JASPER CO. RCB CULVERT REPLACEMENT - TWIN BOX
BRFN-006-4(175)--39-50

RCB CULVERT REPLACEMENT - TWIN BOX

FIELD EXAM CHECKLIST

FIELD EXAM NOTES

BARNROOF FORESLOPE AT SKEWED DRAINAGE STRUCTURE

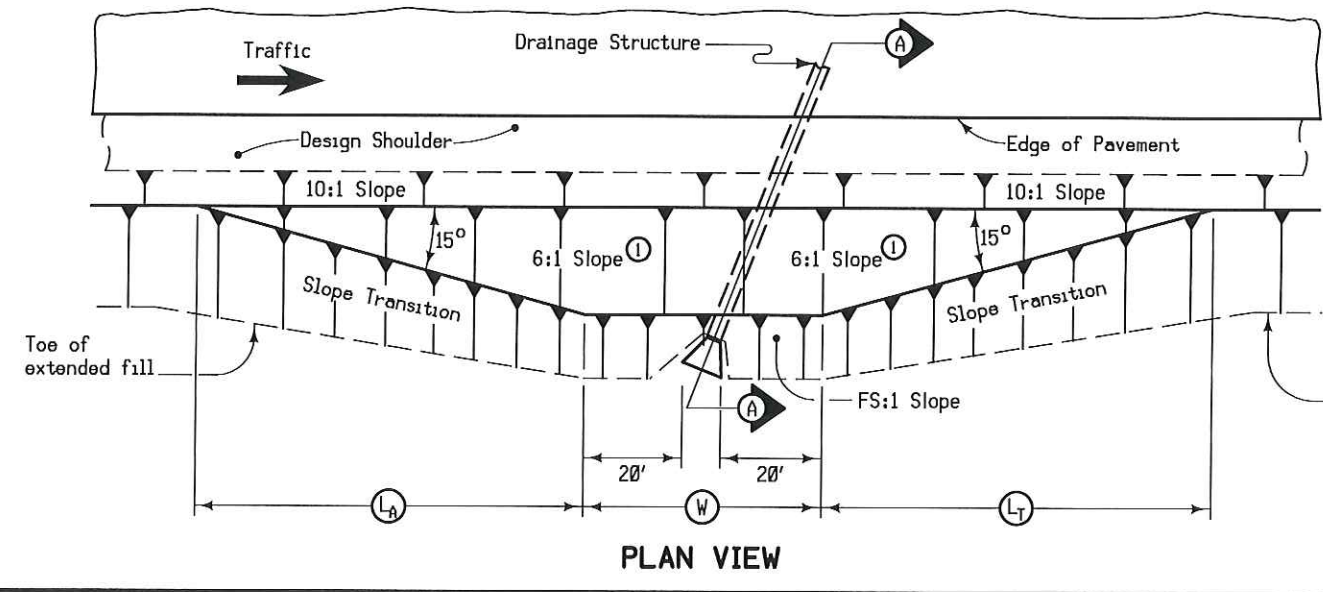
Need paving typical
